TITLE: Passive Residual Heat Removal Heat Exchanger

Document Number: APP-GW-GLN-001 Revision Number: 0
 Title: Passive Residual Heat Removal Heat Exchanger

WESTINGHOUSE ELECTRIC COMPANY
AP1000 Licensing Design Change Document

Fig. 1
Revised AP1000 Housing

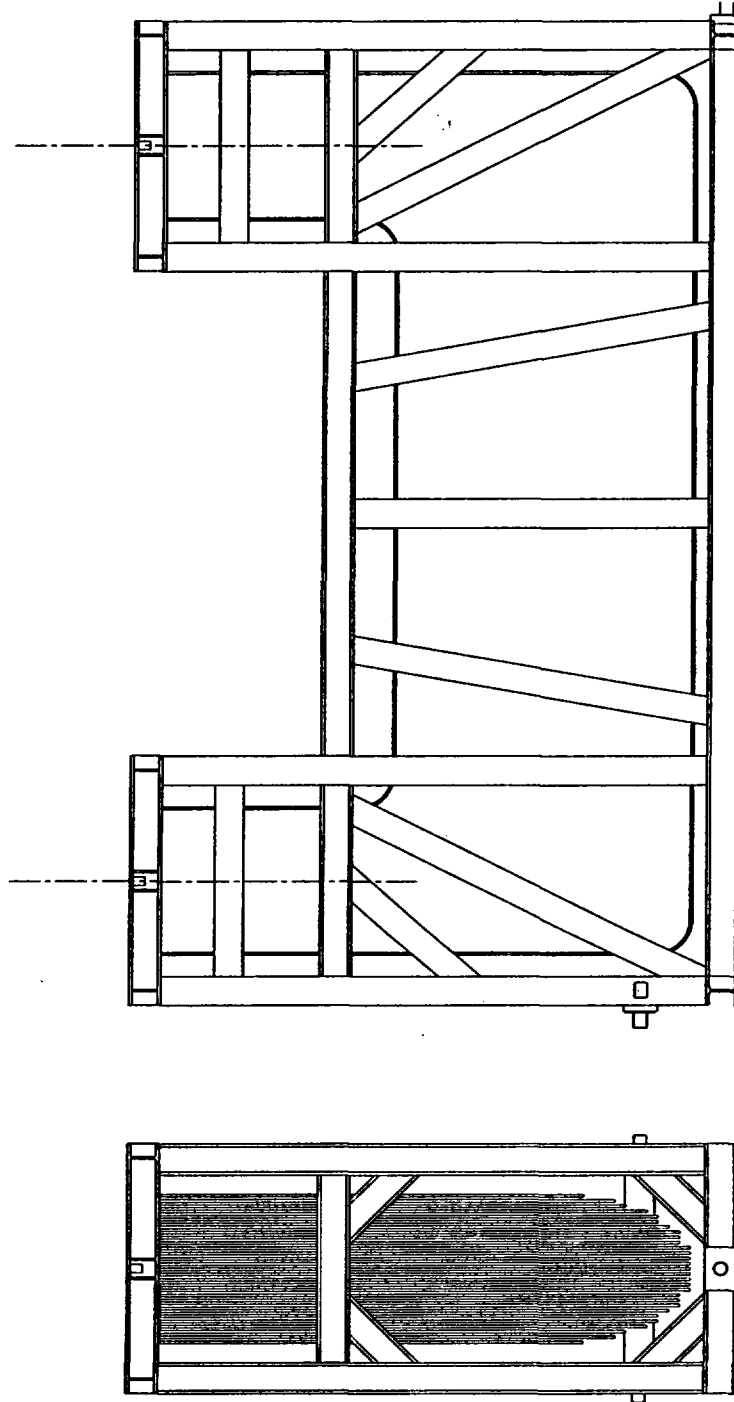
2. Housing

The design evolution of the tube support system resulted in new beams being added to the shroud, in order to shorten the tube support bars and make the support system simpler. Also, the housing has been modified such that it closely matches the tube bundle, thus reducing the component weight and, as a consequence, the loads on supports and IRWST wall.

The housing itself has been given a "C" shape by removing the vertical beams that joined the two flanges; in addition, the width of the structure has been reduced.

Minor adjustments of the tube supports have been included to accommodate the two additional tube rows and one new support has been added in the horizontal leg.

Figure 1 shows the resulting configuration.

Fig. 2
AP1000 – Tubesheet / Housing Flange

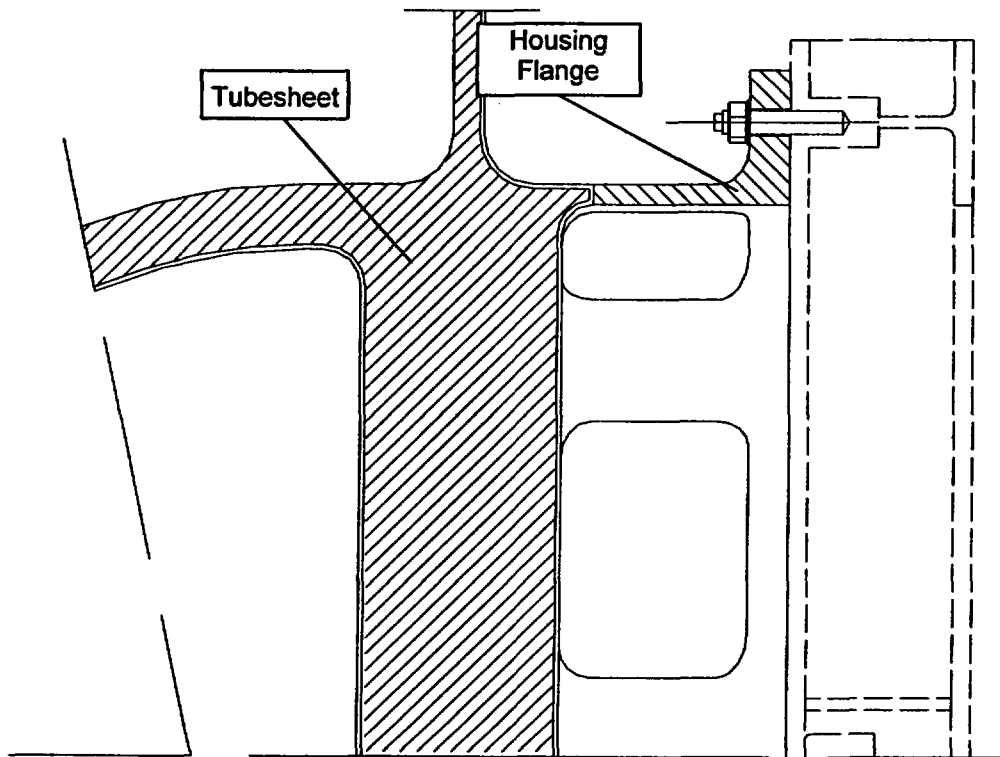
3. Tubesheet to Housing connection

Because of the narrower housing structure, the diameter of the flange that connects the tubesheet to the housing has been reduced: the new flange is attached directly to the tubesheet and has large holes to provide for free circulation of pool water. The counterflange on the housing has been simplified, eliminating the large ring with screwed holes of the earlier design. The flexibility of the new flange and housing eliminate the vertically oriented slots. See Figure 2 for the revised tubesheet/housing flange.

Fig. 3
AP1000 – Upper Support Orientation

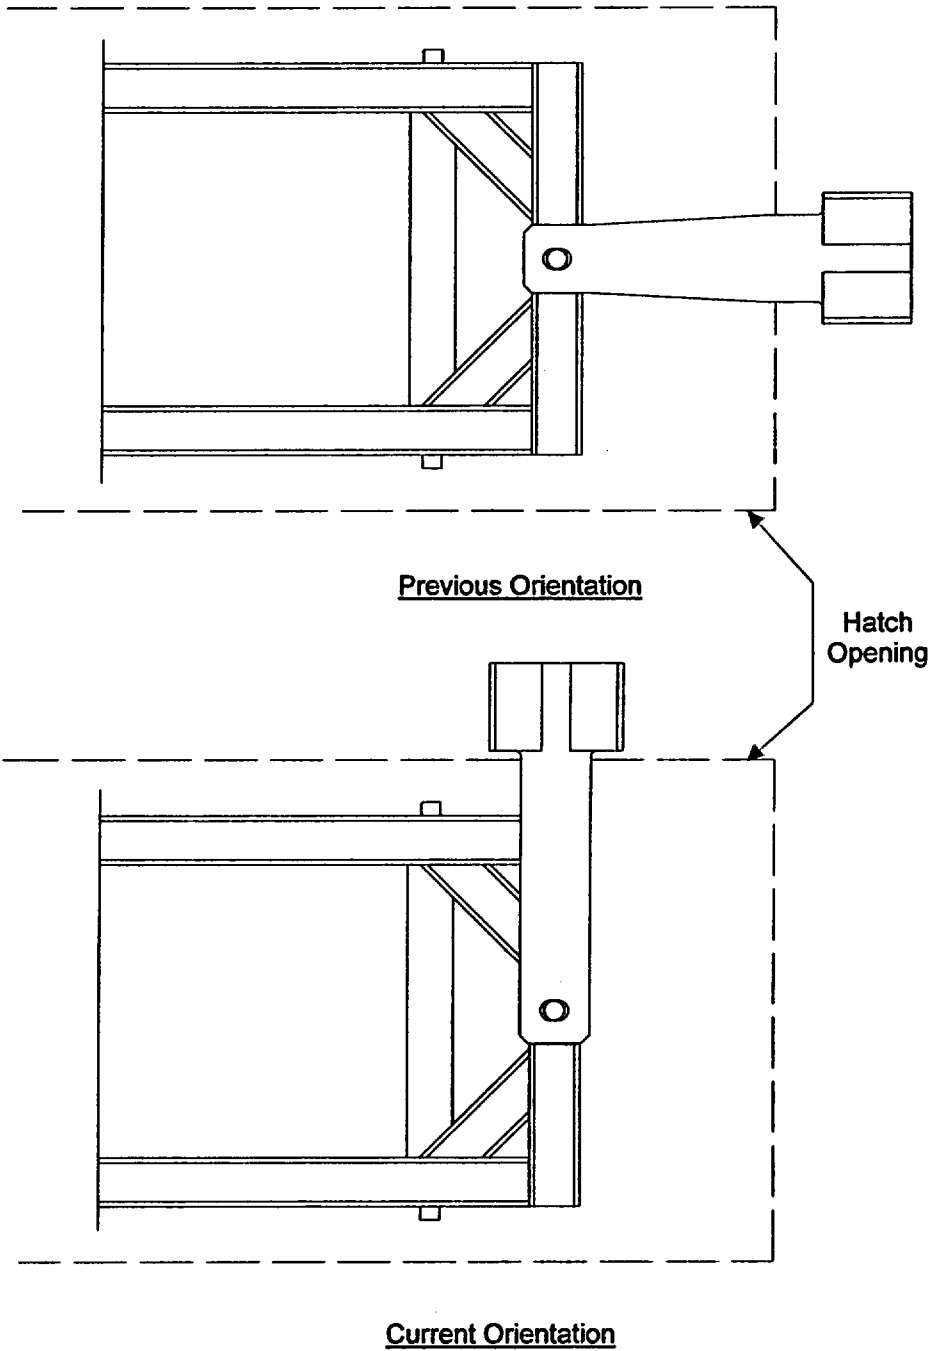
4. Hx supports

The original configuration of the heat exchanger supports is maintained. The heat exchanger is basically supported by the extended flanges, connected to the IRWST wall openings. Additional supports help in sustaining the deadweight and providing restraint against seismic load.

The existing lower supports have been adapted to the new housing, while the upper lateral support has been rotated by 90 degrees, thus eliminating the bending stress as well as reducing its dimensions as shown in Figure 3.

Figure 6.3-5

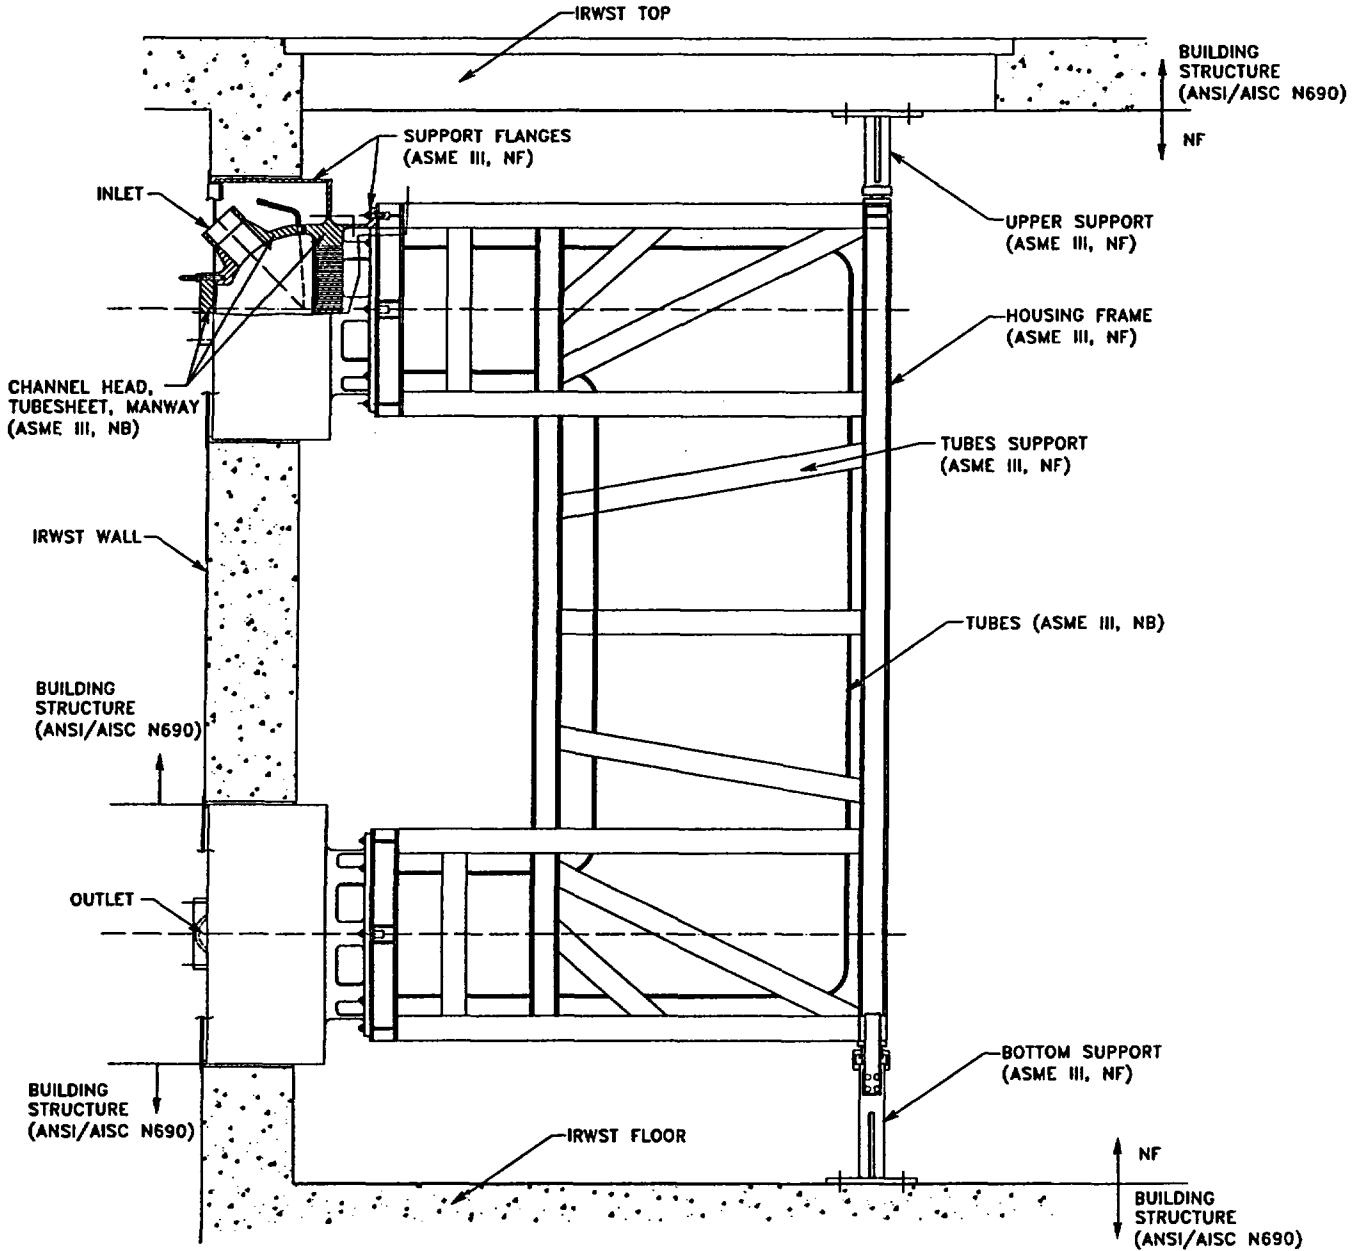
Replace the existing Figure 6.3-5 with the figure below. The revised figure shows a different housing frame and supports.
